Re: **1225 Centre Street – MassDEP File Number 006-1573**

RE: SUBMITTAL – Response to review comments for 1225 Centre Street

RE: SUBMITTAL – 1225 Centre Street Supplemental Narrative

STORMWATER MANAGEMENT PLAN

Photo Dec 12, 2016

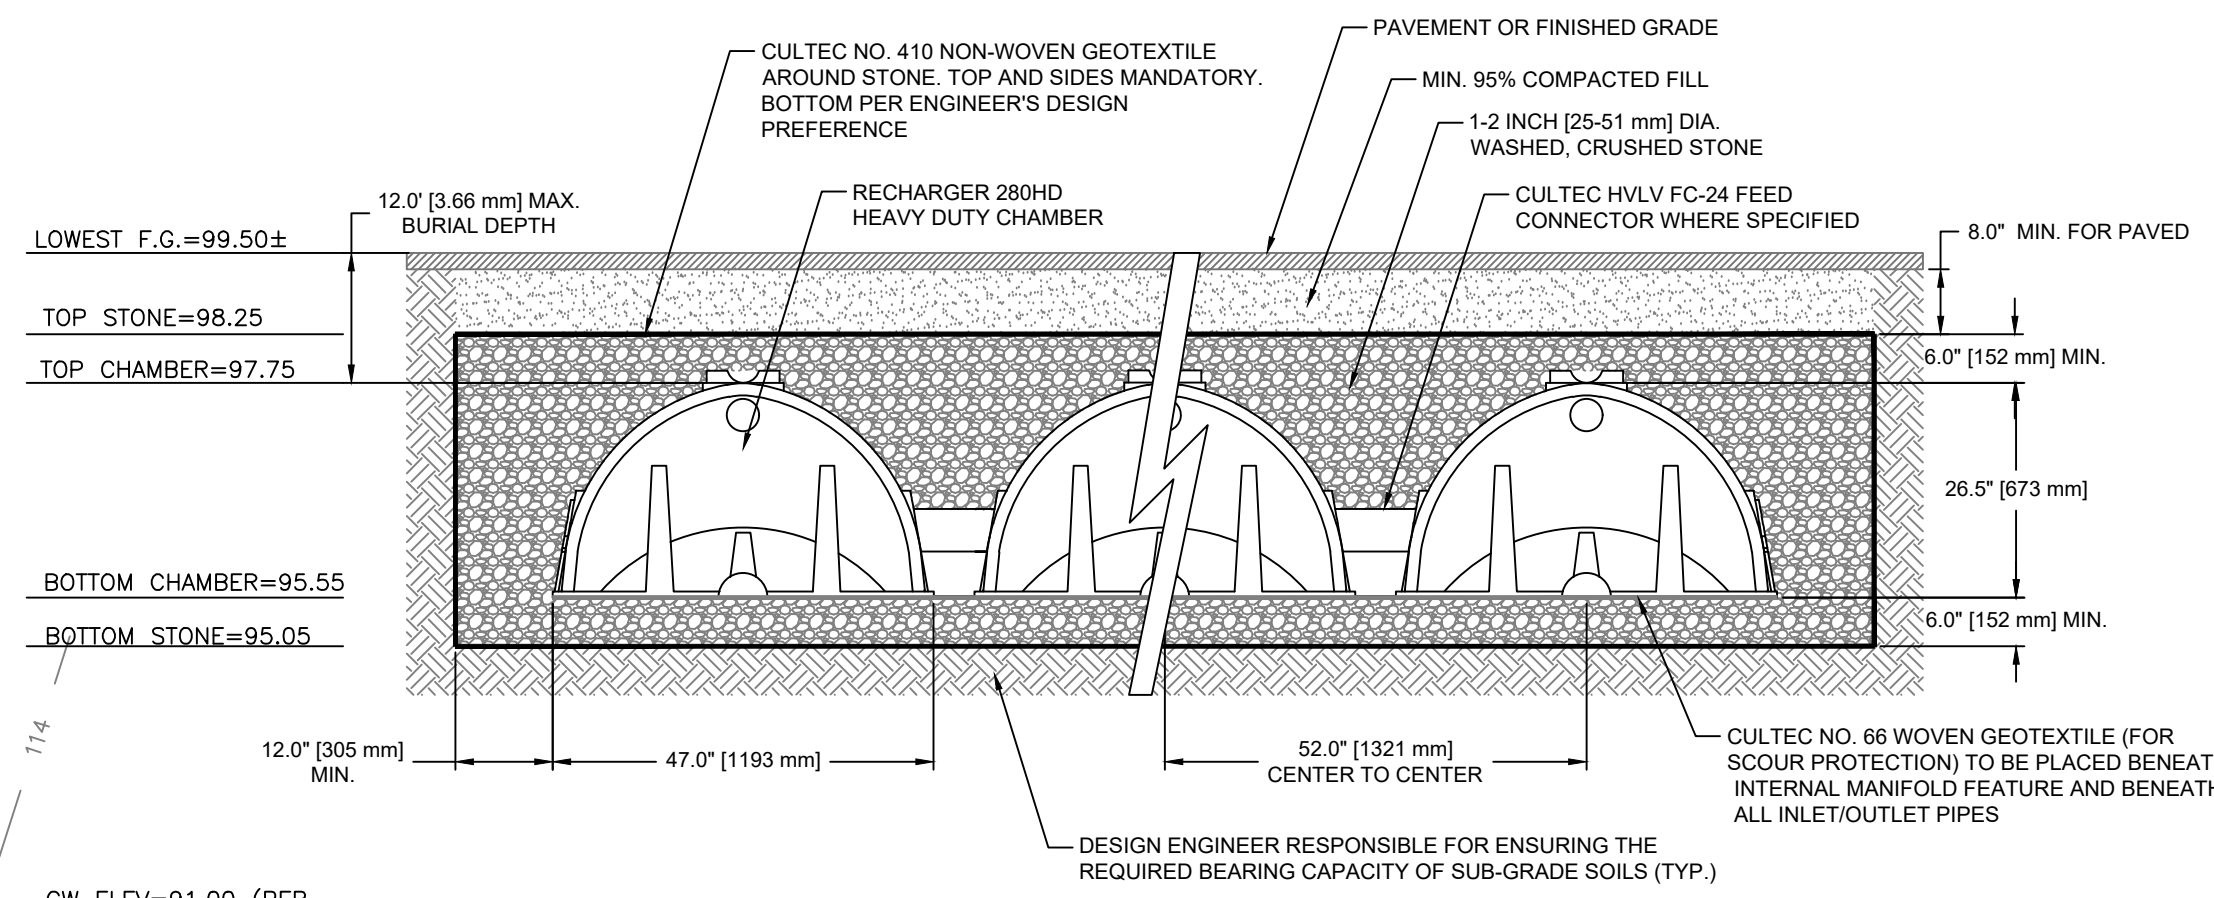
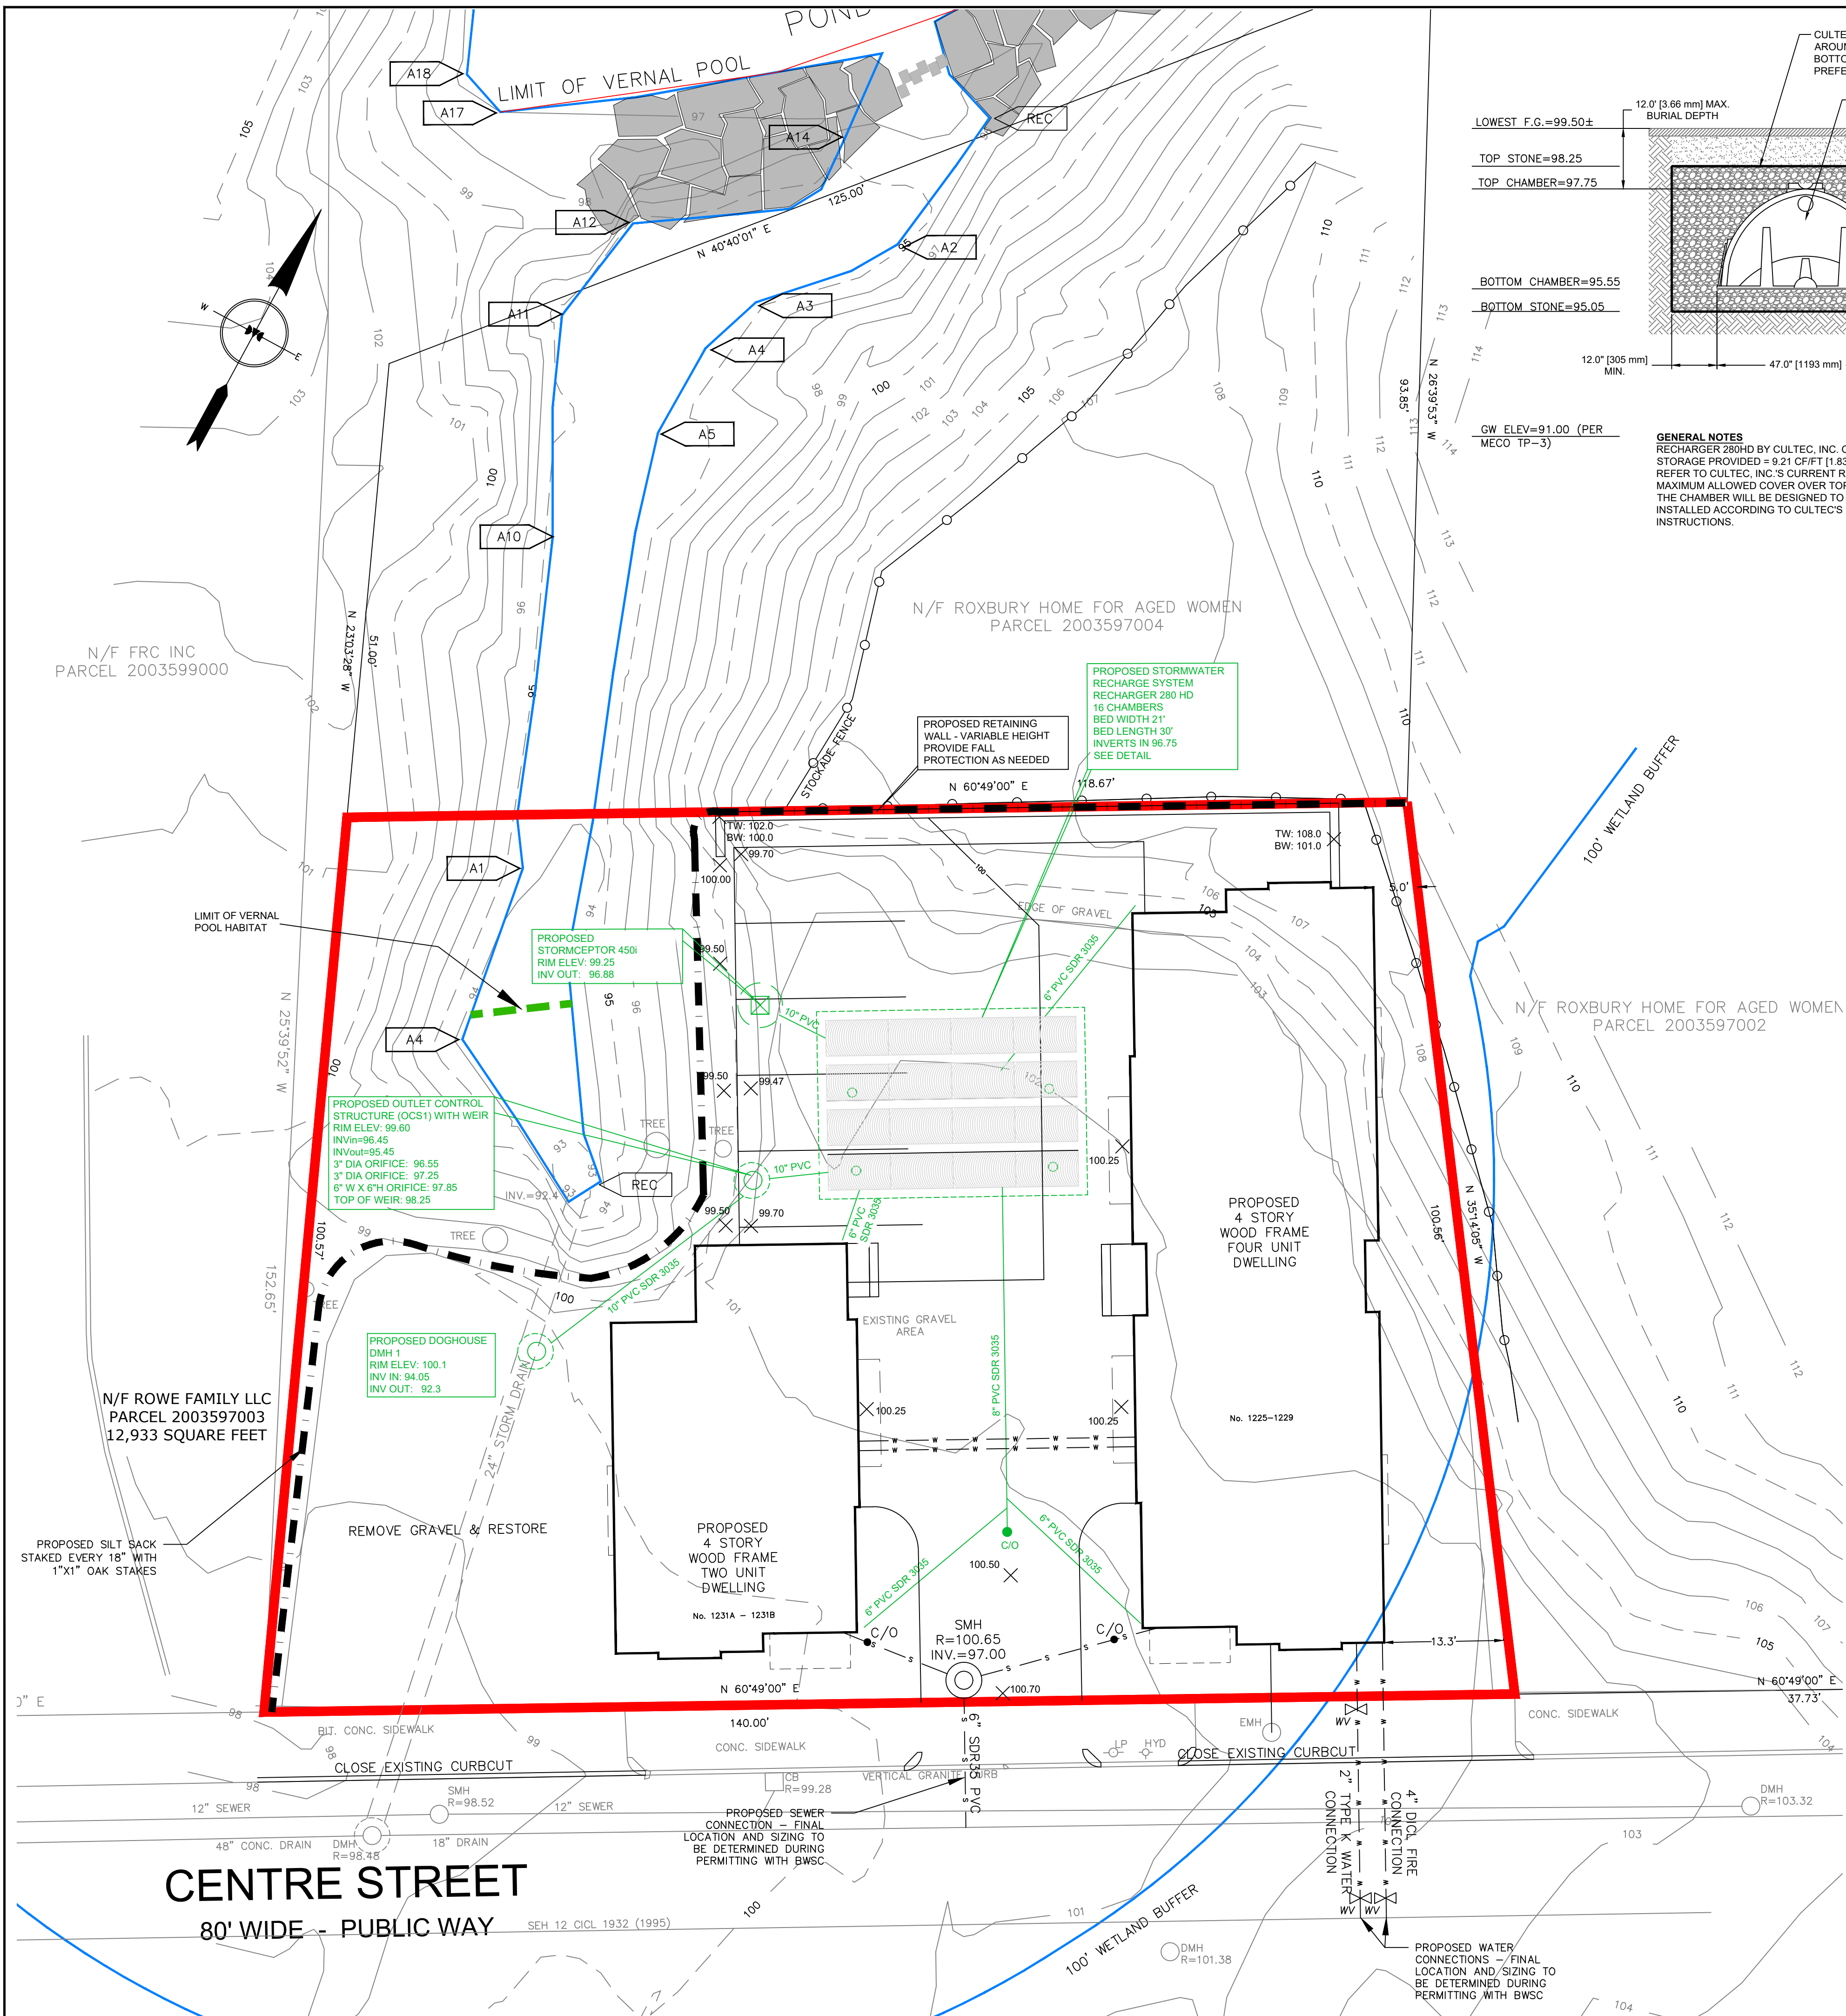
3. Clarification on how the Applicant's delineation is different from CDM Smiths determination (venal pool and BVW.)

At your request, I have reviewed the delineation conducted by CDM Smith for the Boston Parks and Recreation Department in June 2016 that is applicable to the subject property and Rimmer Environmental Consulting, LLC ("REC") provides the following additional information regarding the delineation of wetland resources at the site presented by the Applicant. A review of the CDM report you provided, revised through March 27, 2017, and the accompanying figure depicting the location of wetland flags indicates the wetland boundary is very similar to REC's delineation of December 2016. The CDM figure is based on GPS survey and not a more accurate instrument survey as has been prepared by the Applicant so some discrepancy may be due to differences in the degree of error of survey methods. Of the 44 flags placed by CDM, only 6 are on 1225 Centre Street. Therefore, the written report was largely focused on a description of other portions of their delineation and their data forms were not based on transects at 1225 Centre Street. For this reason, it is difficult to distinguish from the report which flags are intended to represent Inland Bank resource and which are Bordering Vegetated Wetland (BVW) on the 1225 Centre St, parcel. Generally, when there is a very narrow fringe of BVW along a Bank the delineator will flag the higher of the two resources and not both. In the case of CDM delineation, portions of their flagging may depict BVW and portions BVW, depending on which one was most upgradient. However, because both Inland Bank and BVW contain a similar 100-foot Buffer Zone and are protected for similar resource functions, it is a distinction that has little consequence for the project proposed in the Notice of Intent. REC found nearly 100% upland vegetation on the eastern bank (primarily Japanese knotweed) that is closest to the project development and generally no vegetation downgradient of the flags toward the stream channel to the water surface and therefore concluded this was Bank resource. There was a very small amount of wetland vegetation that was included in the delineation on the western bank which could be categorized as BVW.

Below are photos taken on December 12, 2016 showing the CDM flags in blue and REC flags in pink/black stripes. As you will note, the flags are right next to each other and the boundary is very similar.
